SERVICE INFORMATION

No. : SI-V44029-G
Date. : Jan. 5, 1990

PIONEER															
MODEL NO.		*	SER. NO.		MODEL NO.		*	SER. NO.		MODEL NO.		*	SER. NO.		
CLD-3070/KU/CA		A	JL3919001-												
CLD-3070/SD/G		A	JL2914501-												
#	DETAIL OF CHANGE(S)							REASON FOR CHANGE(S)							
1	Deletion of a PCB hinge and addition of rubber cushions to the shield case for VSOP ASS'Y							X	To prevent VSOP ASS'Y from cracking

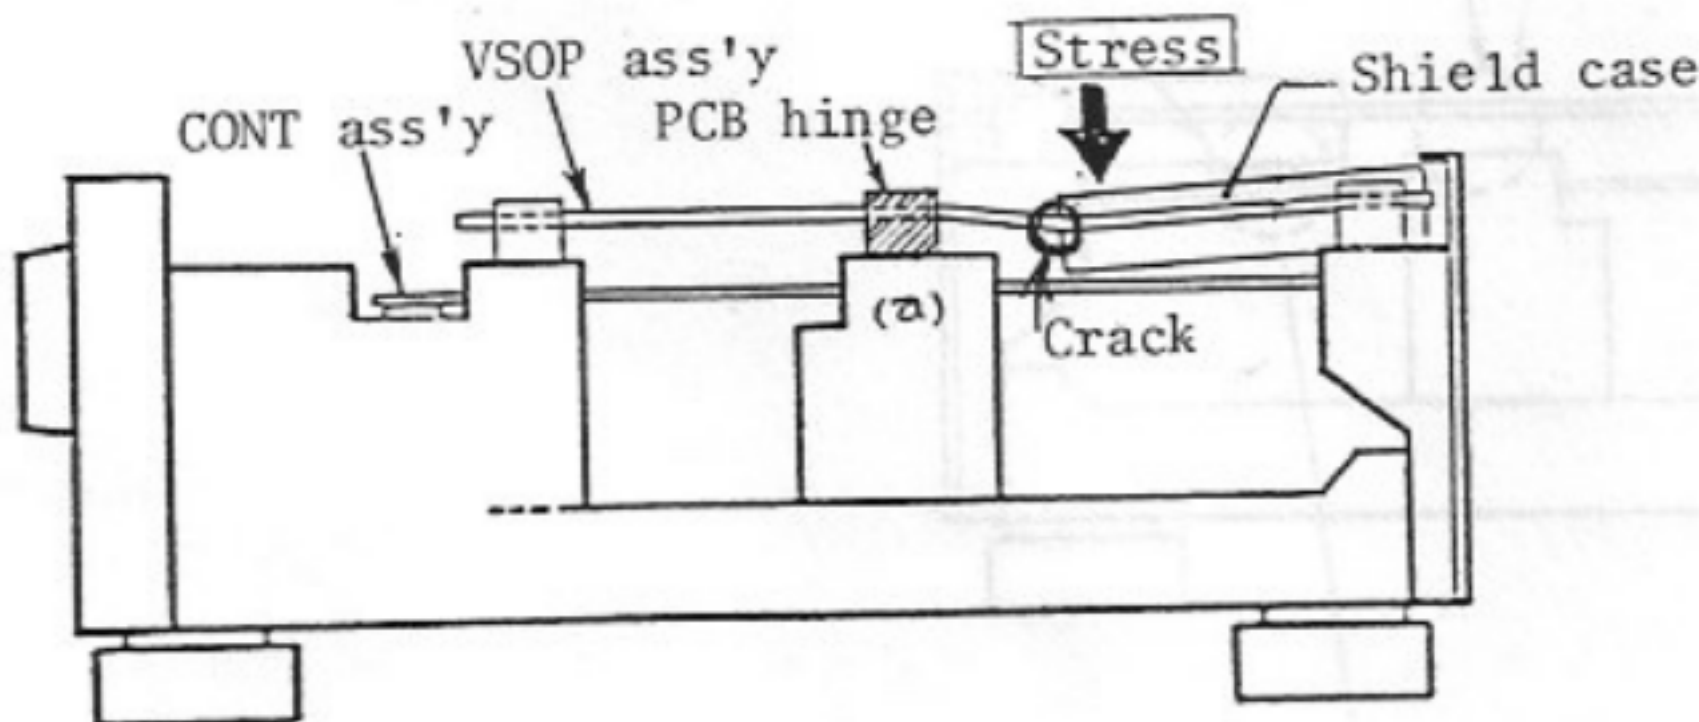
VSOP Ass'y cracks at a certain point.

While the unit is being transported or handled, excessive stress is applied to VSOP ass'y at the position around a PCB hinge as indicated with (a).

- 1) Deleted a PCB hinge.
- 2) Added 2 rubber cushions (VEB1092) onto the shield case of VSOP Ass'y.
